SERVICE BULLETIN

SUBJECT

TR-2600A PLL UNLOCK

1-14-86

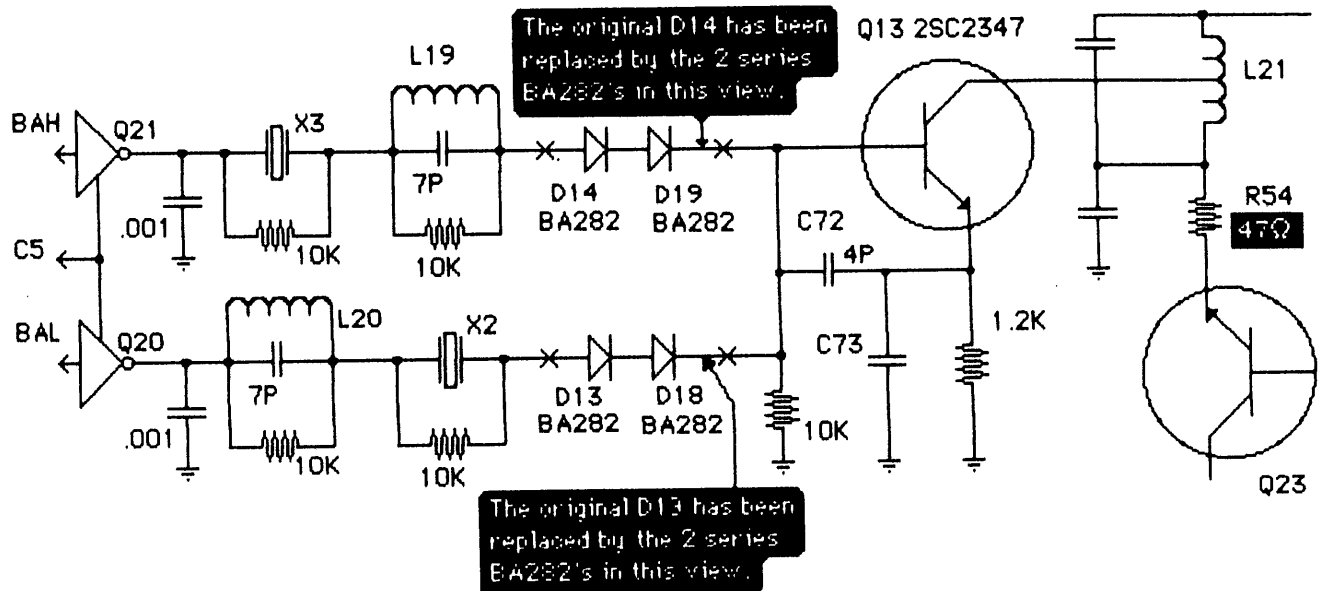
Some cases of PLL unlock on the TR-2600A may be caused by a failure of the crystal oscillator circuit X2, X3, and Q13. This may be corrected by performing the following changes.

On the TX Unit (X56-1470-10)

Replace Diodes D13, and D14 (MA856) with a series pair of BA282's as shown in the diagram below. Also change resistor R54 to 47Ω as shown.

BA-282 diode.....4 each.
47 Ω Chip resistor (RD73FB2A470J).....1 each.

This change is applicable to serial numbers before SN 702XXXX.
Time Required for this modification is 1 hour or less.
